MARK	DATE	DESCRIPTIONS	BY	CH'D
1	07/21/06	E2 CAP BEAM ISD, E2T1 CCO 34	AS	NV
		REVISIONS		23

SAN FRANCISCO OAKLAND BAY BRIDGE
EAST SPAN SEISMIC SAFETY PROJECT
SELF-ANCHORED SUSPENSION BRIDGE
(SUPERSTRUCTURE & TOWER)

PIER E2 DETAILS NO.2

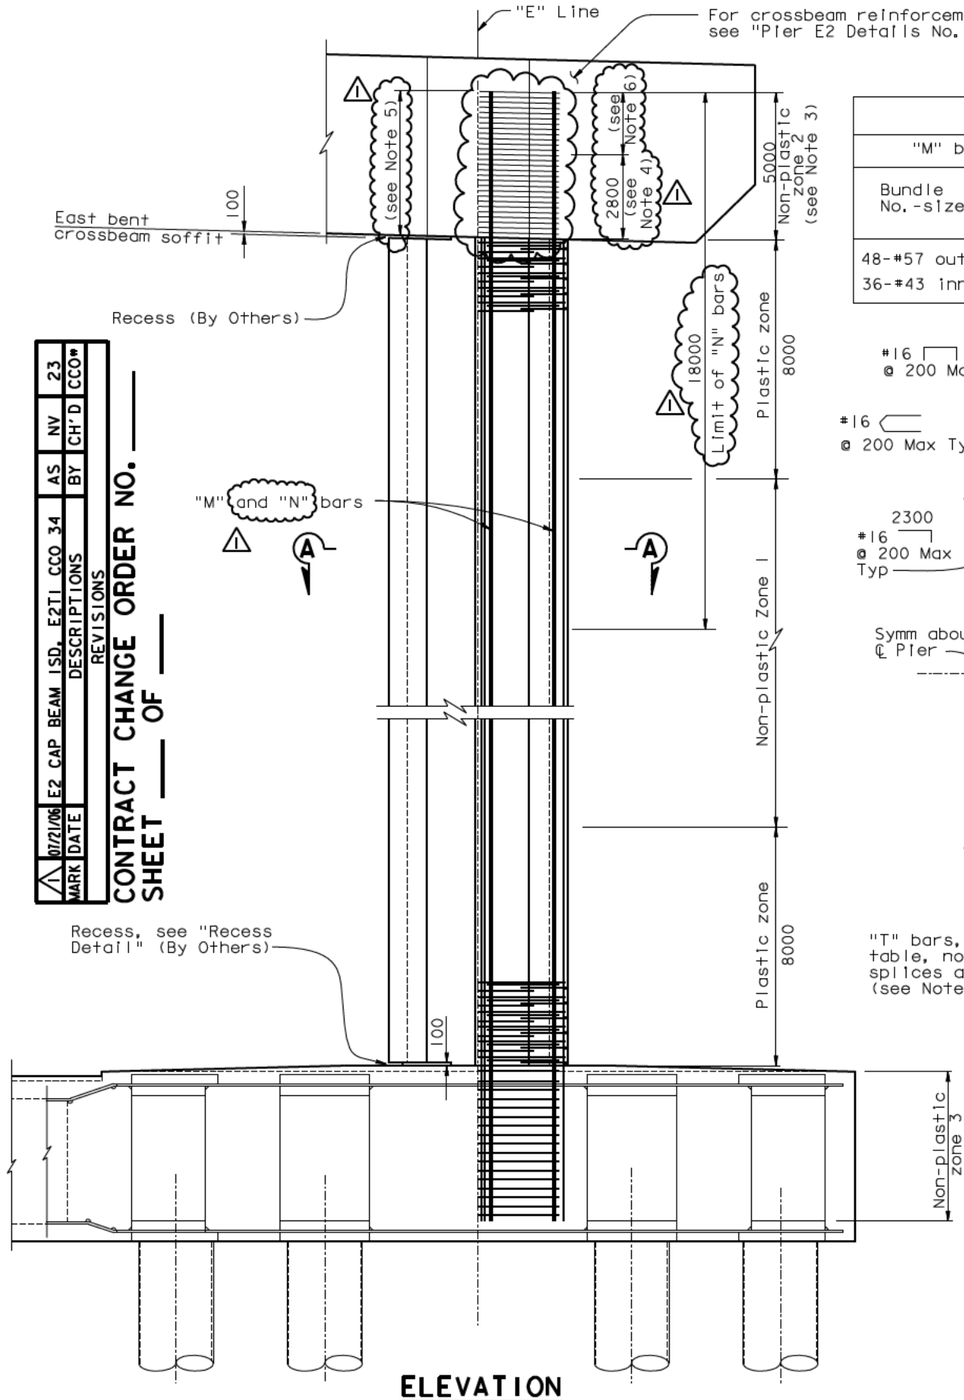
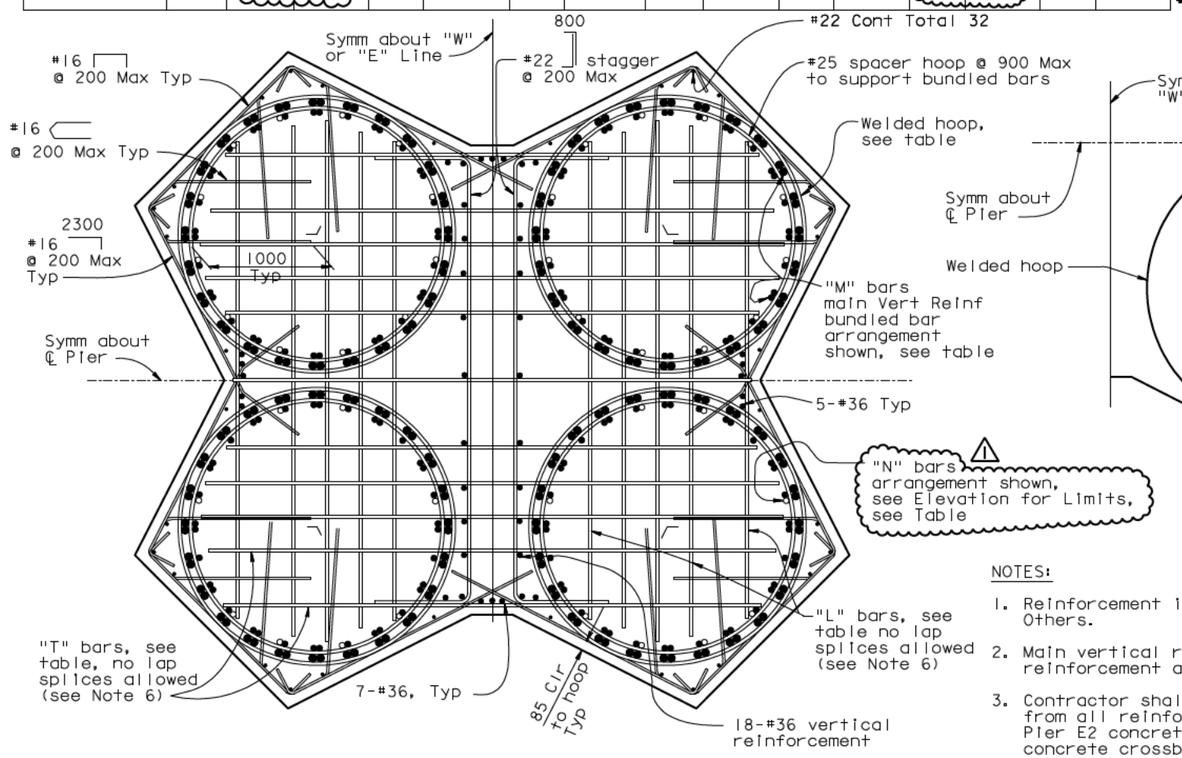
1. Reinforcement is for information only, and by Others.
2. Main vertical reinforcement and hoop reinforcement are "Ultimate" butt splices.
3. Contractor shall remove the corrosion protection from all reinforcing and shall roughen the existing Pier E2 concrete surface prior to pouring the concrete crossbeam.
4. Contractor shall remove existing continuous welded hoops down to soffit. Replace with continuous welded hoops spaced at 175 mm placed at 2% slope up to 2800 mm from soffit.
5. Refer to "Pier E2 Details No.10" sheet for main vertical reinforcement cutoff allowance.
6. Contractor shall remove existing continuous welded hoops and replace with #36 ☐ @ 175 mm placed at 2% slope. See Section F-F on "Pier E2 Detail No.4" sheet.
